# STAFF RECOMMENDATION

M. Marcus  
NCPC File No. 6553

**WHITE OAK FEDERAL RESEARCH CENTER  
FOOD AND DRUG ADMINISTRATION  
NORTH GARAGE 1  
Montgomery County, Maryland**

Submitted by the General Services Administration

**NORTH ELEVATION**

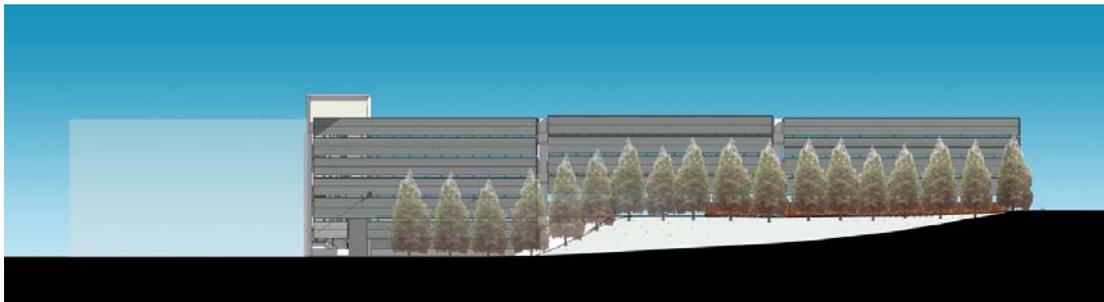
Issues raised during the previous review have been prioritized and addressed in this submittal. The applicant has revised the drawings to show cladding and landscaping of the north elevation, as well as the primary row of trees associated with the garage's west elevation. Aluminum panels added to the north elevation are shown in the submission materials as Option No. 1.

Use of unclad structural materials on the north façade in the previous submittal produced an unfinished appearance and concern for staff. For this submittal, the north façade has been revised to extend cladding with the aluminum panels used on the west and south façades along the entire length of the north façade. The north façade is prominent in that employees approach it first as they drive towards the garage and the CDER Office 1. In addition to providing the first impression to FDA employees approaching the campus from the north, it will provide the public face to the neighbors to the north. Staff notes that the revised construction documents showing the elevation indicate the aluminum panels on the north façade as Option No. 1, but expects this option to be picked up in construction.

**Approves** the final site and building plans for the North Garage 1 at the FDA consolidated campus at White Oak Federal Research Center (WOFRC) in Montgomery County, Maryland, as shown on NCPC Map File No. 3212.00(38.00)41517, as revised from the previous submission to include aluminum cladding on the north elevation, river birch trees planted along the west facade, and eastern red cedar trees along the north facade.

**WEST ELEVATION**

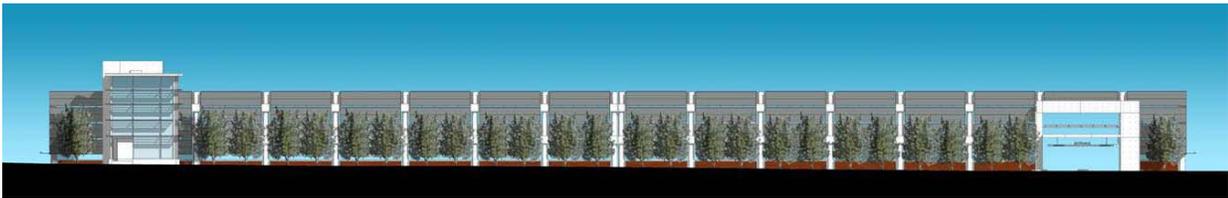
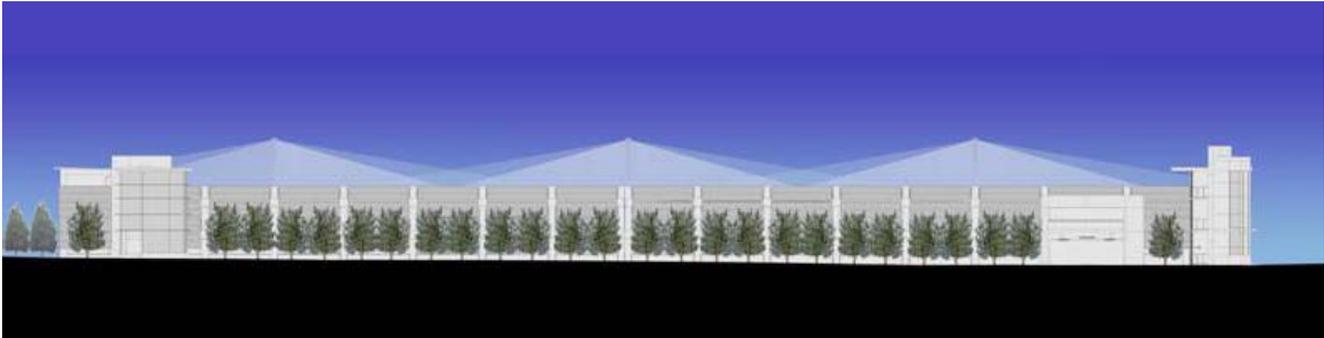
Staff has determined that the concern regarding the need to break down scale of the garage façade and expanse in the horizontal direction has been mitigated by the applicant's decision to plant trees along the west facade now, rather than waiting until completion of the campus. Ten to 12 feet high when planted, the river birch trees, with three trunks, will provide variation through shade, color and texture.

The species of trees selected by the applicant for the west facade is relatively fast growing, which will help to mask and soften the building mass in a relatively short time. In addition the row of trees will begin to create a pedestrian-scale environment, shade the western facade of the building to reduce the potential heat gain, and extend outward beyond the buildings to shade a pedestrian walkway as envisioned in the master plan. When the river birch trees lose their bark in the fall, they will turn a shade of silver which should compliment the grey titanium color of the perforated aluminum panels. The applicant has indicated and staff concurs that the extensive construction planned on the site make greater investment in landscape materials at this time impractical. Staff expects that concerns about pedestrian connections between buildings will be addressed at a later date, as the design for the campus evolves. Planted bio-retention areas to the east will not be designed and constructed until the expansion of the garage at a later phase. Since storm water discharged to the planted bio-retention area to the east would be collected by inlets and piped to the existing storm water quantity management facility next to the Central Utility plant, the bio filtration through the planted bio-retention area would simply be skipped and drainage routed directly to the storm water detention basin until the bio-retention area is constructed with the expansion.

*Site and Landscape Design*

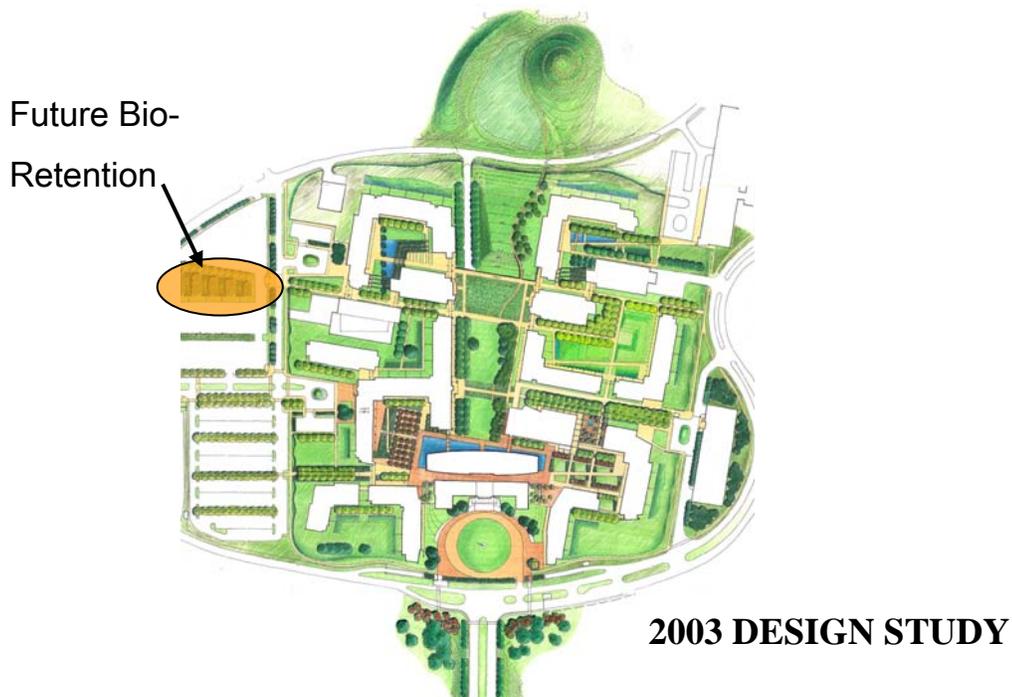
The impacts of top tier pole mounted lighting on communities to the north have been clarified in this submittal. It appears that existing deciduous trees at the property line would provide some canopy screening at eye level of observers from off campus. The main mitigation to contain light pollution from spilling into existing communities is the lighting design and layout. The lighting has been designed to minimize spill-over to adjacent property. Low cut off down lights will be mounted on ten 21-foot-high poles. The lighting has been designed to achieve the

minimum 1 foot candle lighting required for the security cameras. Based on computer modeling, the applicant believes that no measurable light from the fixtures will reach the adjacent property to the north. The rendering that was submitted illustrates a previous layout where light would be directed in three downward cones from light poles to the top tier. The current scheme should show two rows of five fixtures each, with five downward cones of light rather than three.
